CITY OF KIRKLAND

132ND SQ. PARK DEVELOPMENT PROJECT
JOB NO. 47-20-PW CIP No. SDC1070000 / PKC1340000

ADDENDUM NO. 1 TO THE PLANS, SPECIFICATIONS, PROPOSAL AND CONTRACT

Issued This Date: Monday, April 19, 2021
Bid Opening: **Remains the same – April 21, 2021 @ 1:00 PM**
Place of Opening: Kirkland City Hall, Council Chambers

SSK-01

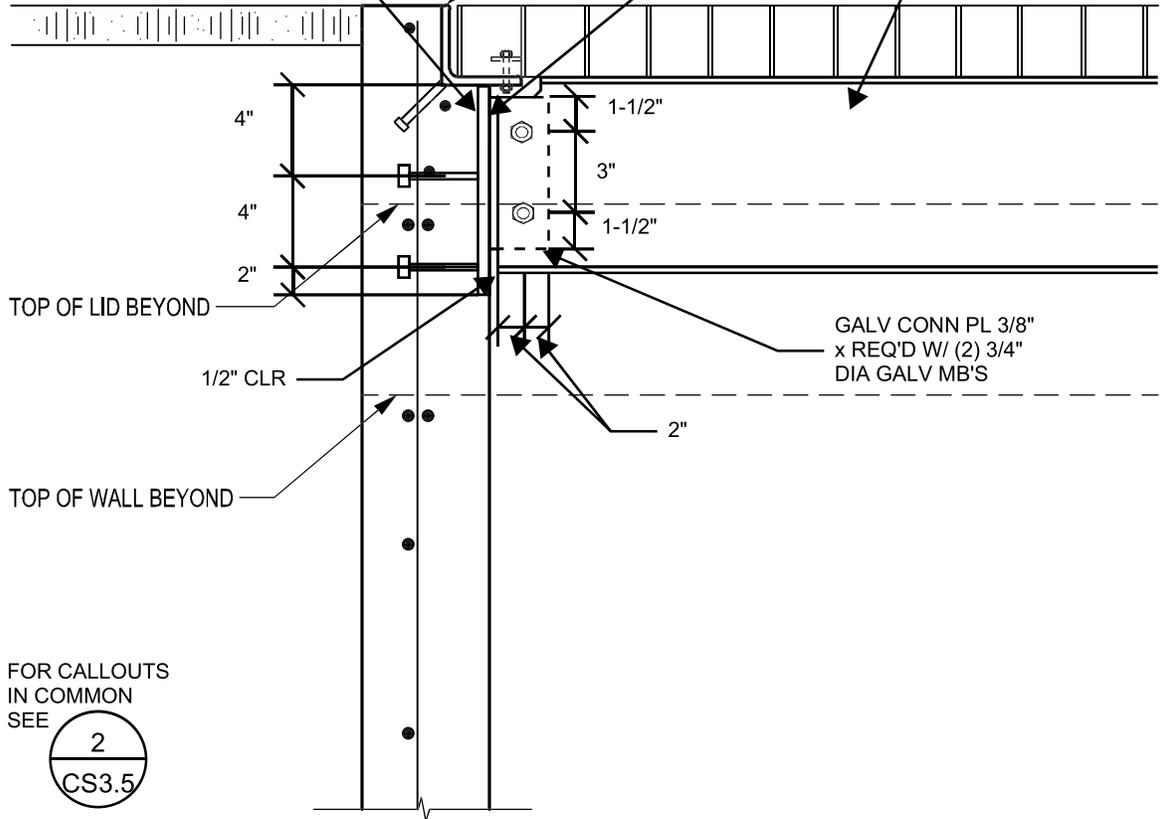
Description: Grating support beam revision for vault access hatch on sheet CS2.1. See attached sketches SSK-01 & SSK-02 for the added details which show the supports for the access hatch

GALV EMBED PL 3/4" x 8"
x REQ'D W/ (4) 3/4" DIA x 5"
WHS AT 6" GA

EMB L AT GRATING PER 1
CS3.5

GALV W8x15 AT 3'-6"oc
(MAX) - COORD SPACING
W/ ACCESS HATCH REQ'S

GALV CONN PL 3/8"
x REQ'D W/ (2) 3/4"
DIA GALV MB'S

Payment for the supply, attachment, and installation of the support beams as detailed in SSK-01 & SSK-02 shall be included in bid item 95 "infiltration facility".

VAULT LID FRAMING REVISION - SHEET CS2.1

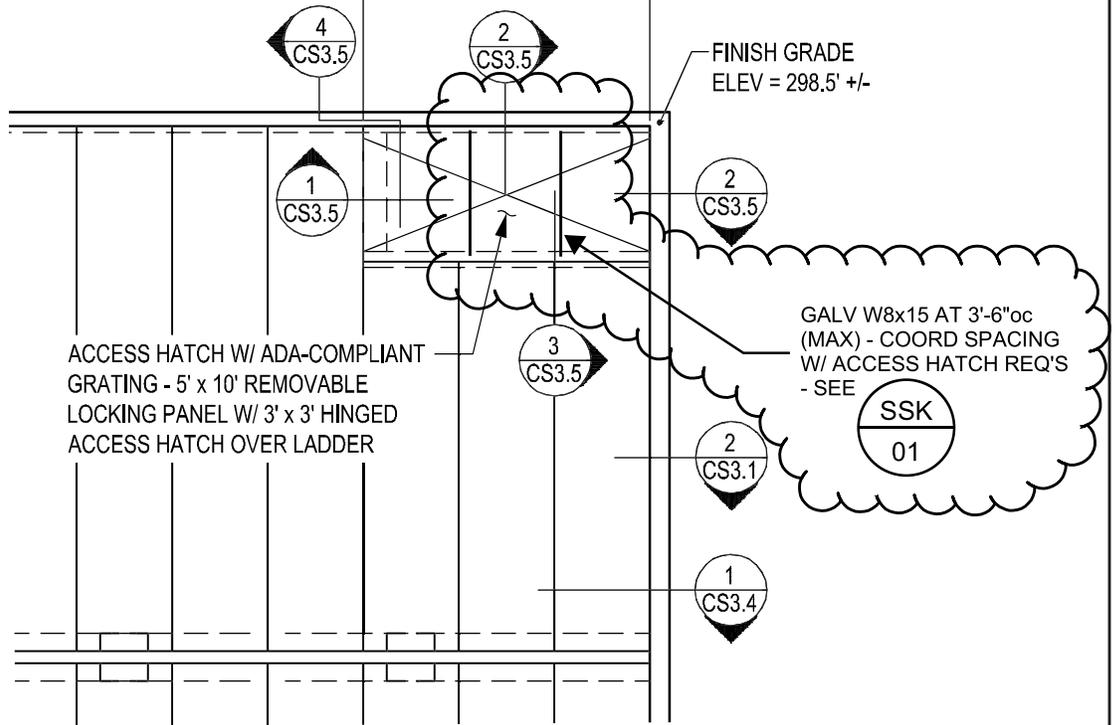
12 1/2" THICK x 15'-0" LONG HOLLOW CORE
PRE-CAST PRE-STRESSED CONC PLANK

(5) 12 1/2" THICK x 22'-0" LONG HOLLOW
CORE PRE-CAST PRE-STRESSED CONC
PLANKS AT 4'-0" OC = 16'-0"
